Subject: Indian Point 3 Nuclear Power Plant  
Docket No. 50-286  
Safety System Outage Modification Inspection  
(Design) Report 87-013

RESPONSE TO SSOMI REPORT 50-286/87-13

This report is prepared in response to SSOMI Report 50-286/87-013 transmitted by NRC letter dated September 8, 1987. The report is organized in a format which corresponds to the subsections presented in the SSOMI report. Some of the NRC findings have been summarized.

RESPONSE TO ITEM 2.2.2  
(MAGNITUDE OF VERTICAL FORCE)

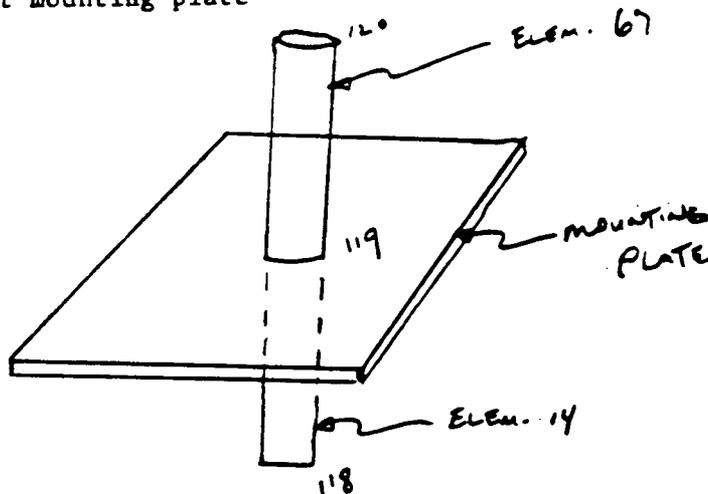
### Response (3)

The Authority does not agree that there is an inconsistency in the vertical force. Attachment 3 demonstrates that the computer model used by I-R is correct and the results are in reasonable agreement with the expected behavior.

# Tension and Shear Interaction.

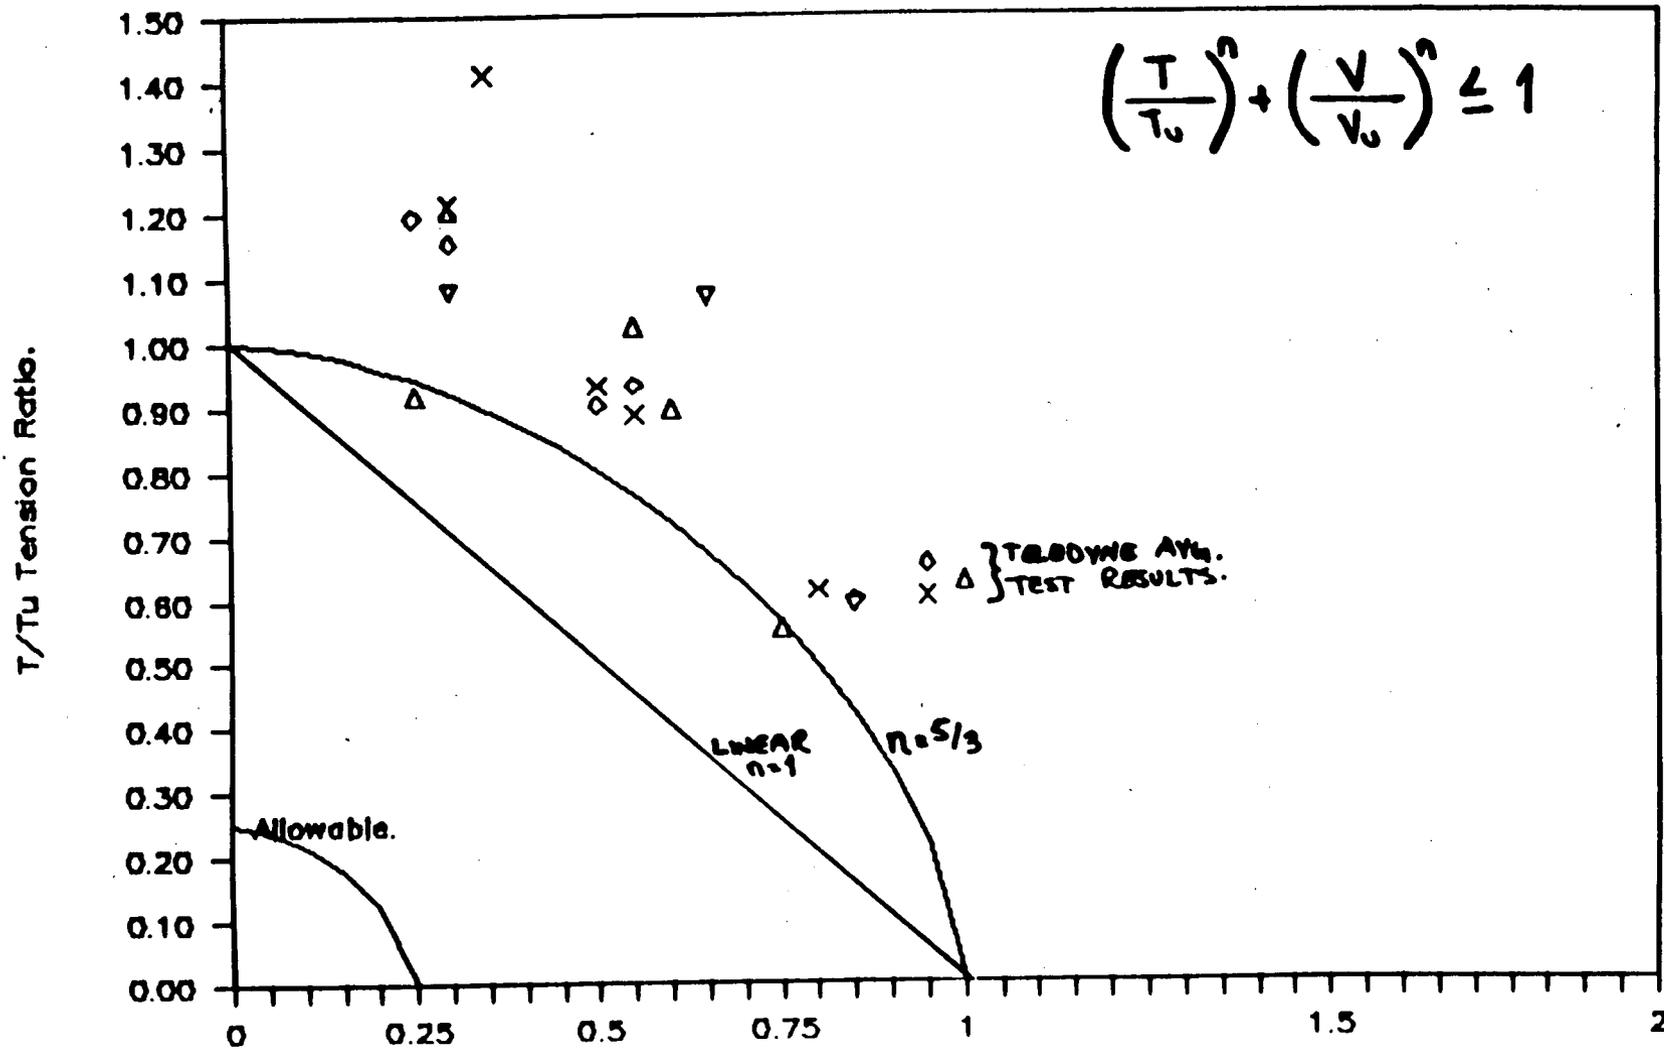
Calculation No. 840223-CA is a pipe support calculation for modification MOD 86-03-009 RCS. Several of the support base plates were evaluated consistent with the methodology prescribed in the licensee's commitment to IE Bulletin 79-02. However, the base plate evaluation for 8 supports (RC-R-343-4A-H, RC-R-343-4B-H, RC-R-343-105-H, RC-R-343-106-H, RC-R-342-106-H, RC-R-70-204-R, RC-R-70-205-R and RC-R-70-206-R) were performed with a less conservative approach. If the methodology of IE Bulletin 79-02 is applied to the supports in question, then some of the anchor bolts are inadequate. Although the use of the alternate approach may be technically acceptable, approval for relaxation of a licensing commitment should have been obtained from NRC prior to performing the modification.

During the NRC audit, the 8 supports mentioned above were recalculated using the approach outlined in the response to NRC I&E Bulletin 79-02 as described in a letter from P. J. Early (NYPA) to B. H. Grier, OIE, NRC, Region I, (IPN-79-1979), dated July 6, 1979. As a result of this recalculation, it was determined that all of the anchor bolts for the 8 support base plates were adequate as designed. Therefore, the subject pipe supports can be considered adequate as designed and in compliance with I&E Bulletin 79-02 requirements.

Shear/tension interaction tests performed by various organizations (e.g. EPRI, Teledyne, References 1 and 2) have shown that a linear interaction shear/tension equation is conservative for the Hilti Kwik bolts that the Authority specifies. Figure 1 makes a comparison between the interaction equation with power factor of  $5/3$  vs. the Teledyne test results. The  $5/3$  power is a more realistic design equation and still is bounded by the test results. Also, additional conservatism is introduced by ignoring the interface friction, due to the applied moment, between base plate and concrete.

It should be noted that NYPA uses the highest of the FSAR "faulted" or "upset" loads in evaluating the safety factor of 4 for the bolts. Hence, the allowable loads shown in Figure 1 are determined to be highly conservative.
